MODIFIED

Sluckey's AB763 Tremolo Mods

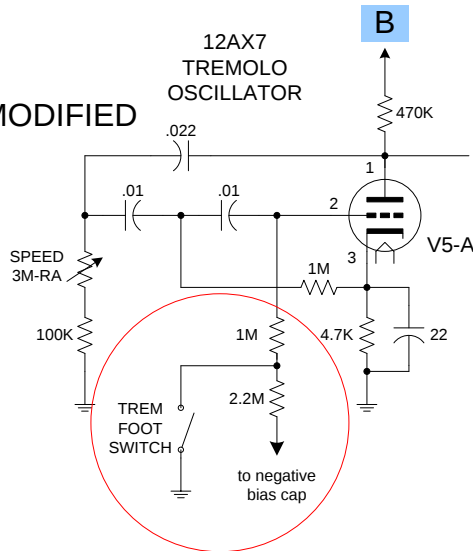
- 1: Change to 0.022uF for slower speed.
- 2: Cap not shown on original Hoffman layout.
- 3: Change to 100K-220K for stronger tremolo.
- 4: Change to 0.047uF for stronger tremolo.
- 5: Replace 4.7K||22uF with LED for much stronger tremolo and visual indicator.
